MEMORANDUM

TO: ARCHITECTURAL REVIEW BOARD
FROM: Kate Schwartz, Historic Resources Planner
DATE: June 13, 2016
SUBJECT: Certificate of Appropriateness for demolition and exterior alteration at 319 Prince Edward Street

Matt Revell requests a Certificate of Appropriateness to demolish the one-story rear addition, construct a new two-story rear addition, alter the roofline, and install a new front porch on this single-family residence.

1927 Sanborn Fire Insurance Map

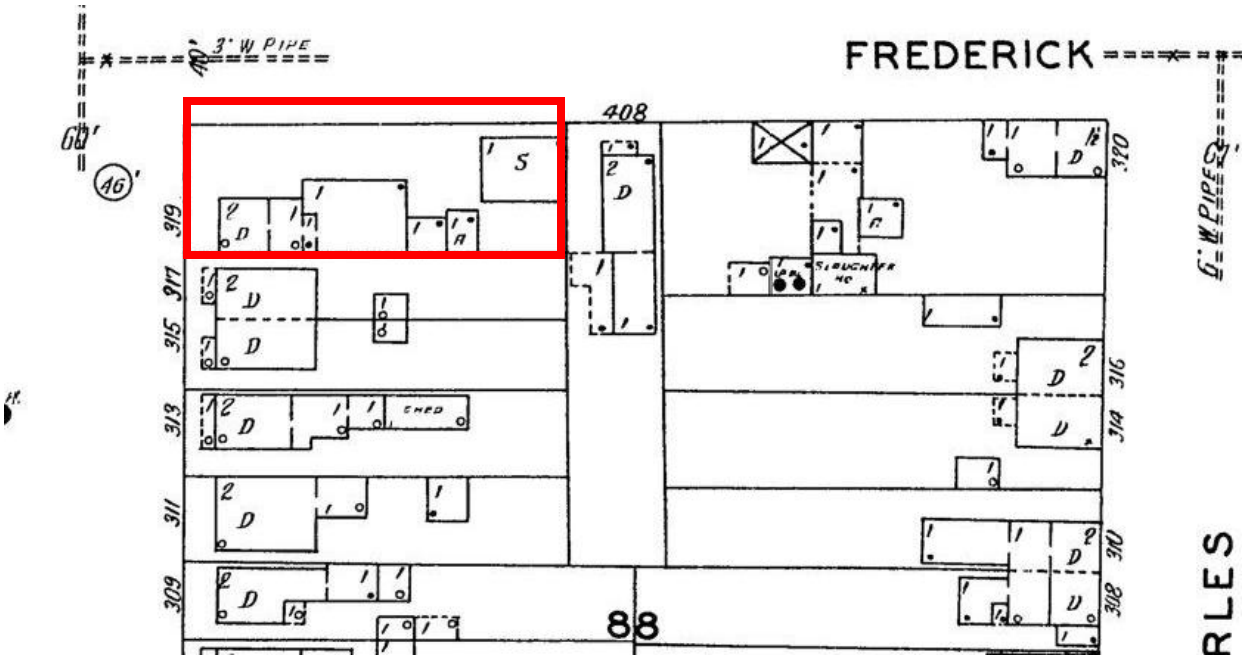
The applicant proposes to construct a new two-story addition on the residence, using the c.1927 building footprint as a model for the new addition. In addition, a second story would be added to the rear half of the original portion of the structure. To accommodate the new addition and allow the roof to shed water, the applicant proposes to alter the roofline and angle the shed roof towards the street rather than the rear of the house. Staff recommends a shallower roof pitch than that depicted in the submitted image to ensure that the façade retains its original appearance from street level.

Existing Conditions

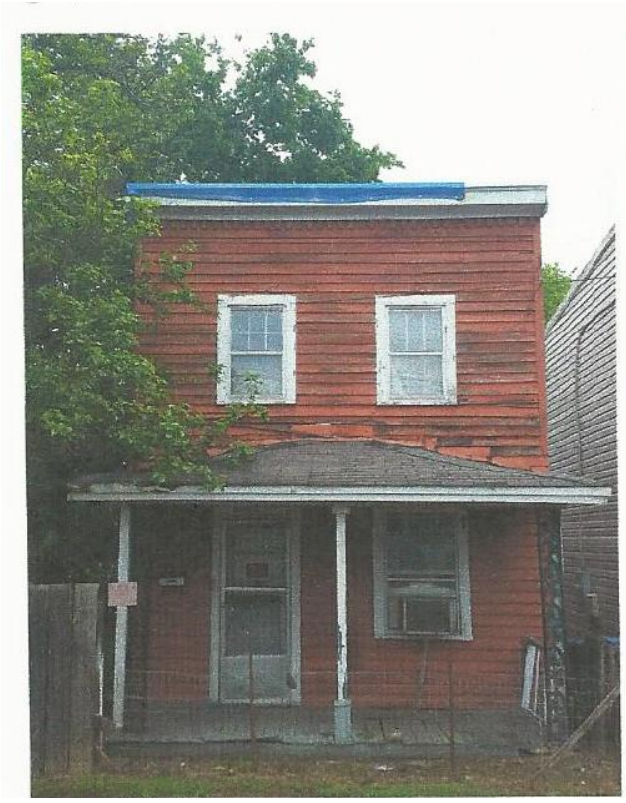
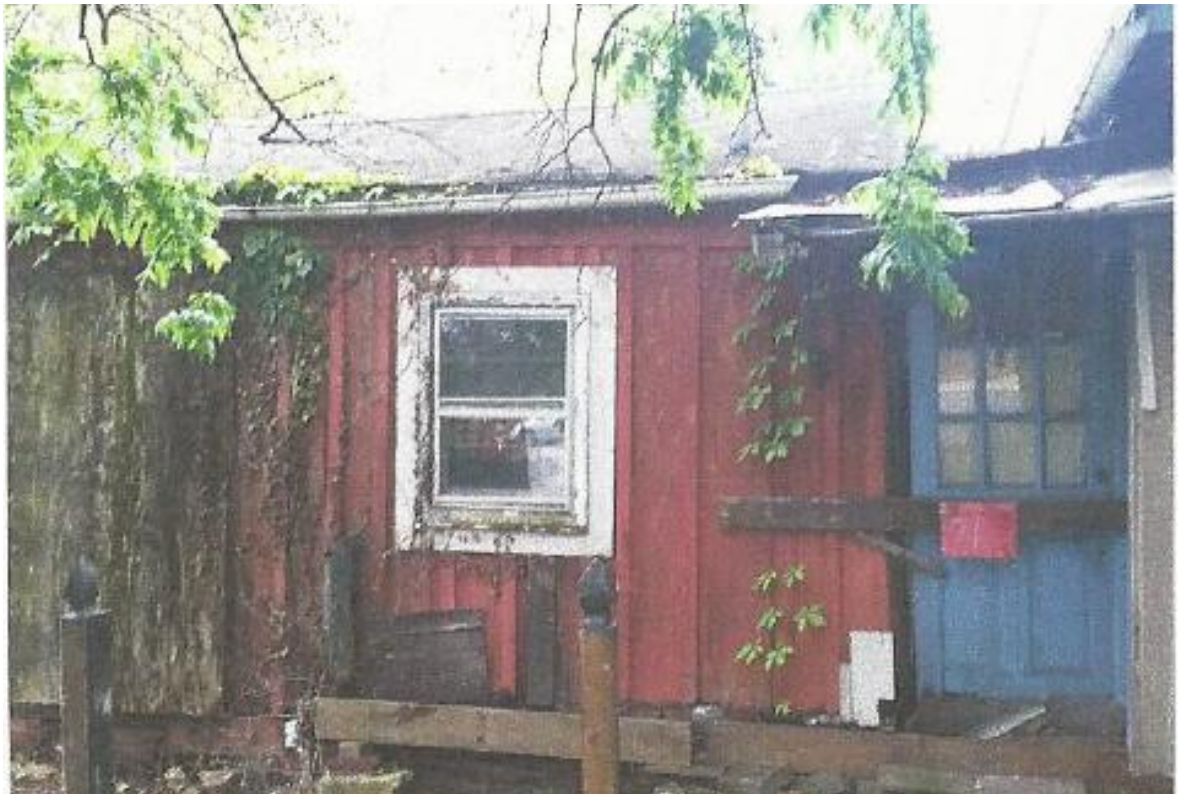
The original structure, located closest to Prince Edward Street, appears to be structurally stable with the exception of a failed second-story roof. This has currently been stabilized. However, the roof on the rear addition failed several years ago and has caused that area to become wet and unstable. This deteriorated

area is contributing to the migration of moisture into the original structure. There is a clear delineation between this addition and the original structure, and staff is concerned that the moisture issues in the addition will cause accelerated deterioration in the original structure. The addition can be removed without damage to the primary structure, and staff recommends approval of the demolition in order to prevent further deterioration of the 1890s residence.

The condition and structural integrity of the building or structure.	Poor; the addition is extremely deteriorated and cannot be reasonably rehabilitated. Moisture and degradation in this addition is threatening the condition of the original 1890s structure.
Effect on surrounding properties.	Removal will enhance use of the site and will not adversely impact the historic character.
Inordinate hardship.	Unknown.

Partial approval of the Certificate of Appropriateness for demolition of the rear one-story addition.

SITE PLAN SKETCH

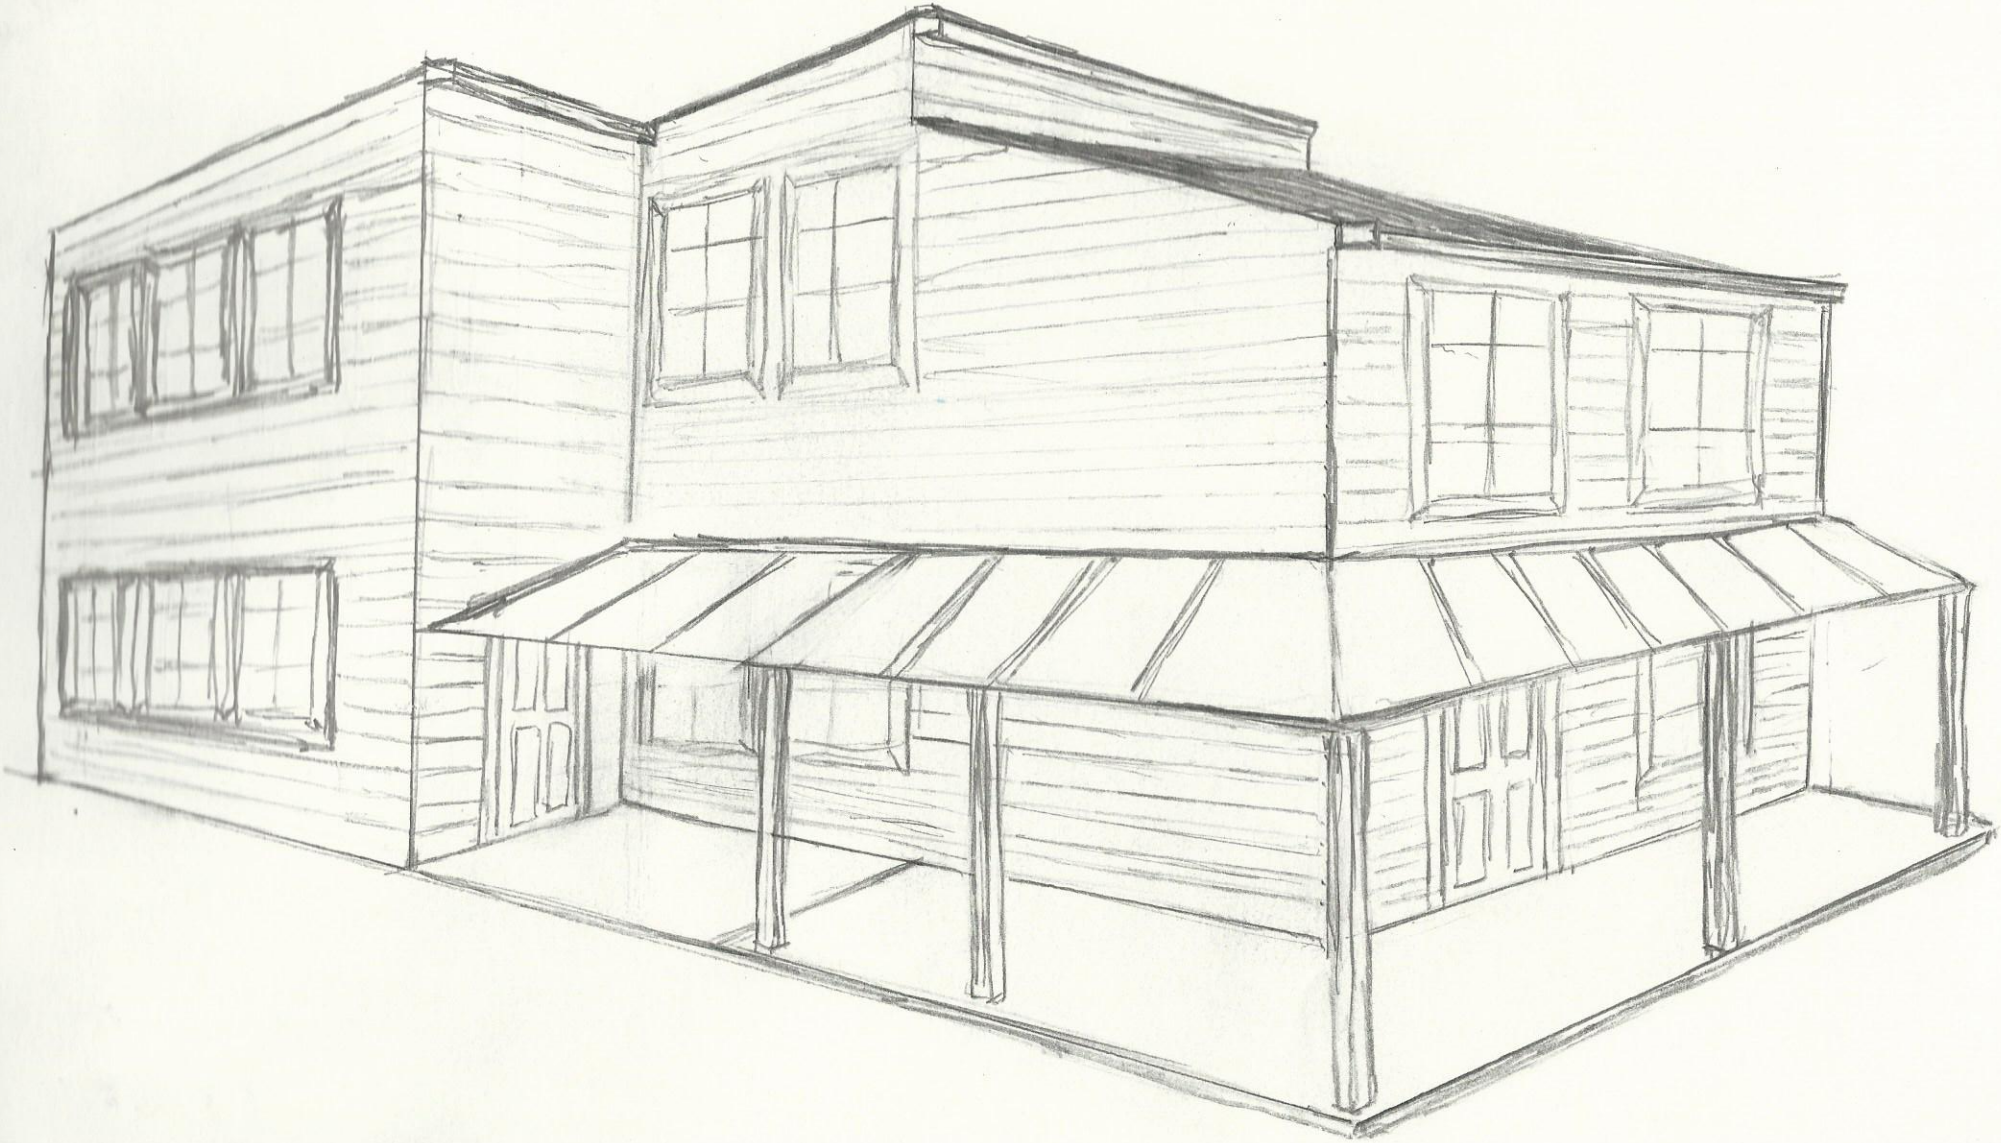
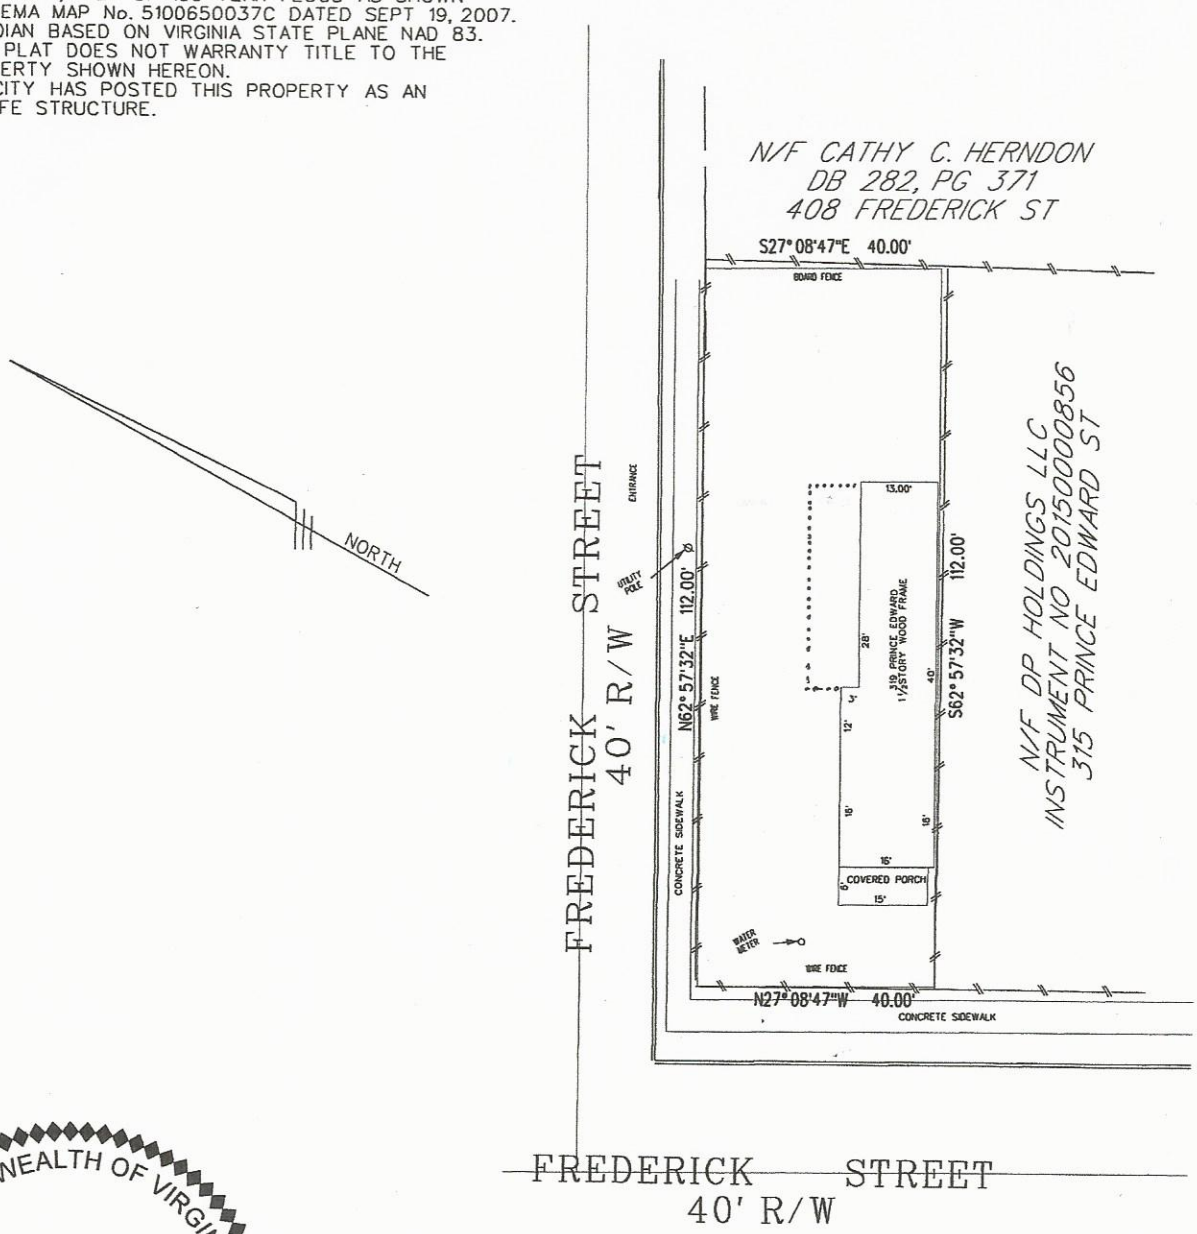
Staff finds that the site planning and scale of the proposed addition meet the standards of the Historic District, but recommends continuation of the application to allow for additional consideration of the massing and design details.

Continue the application for new construction to the July 11, 2016 hearing of the ARB.
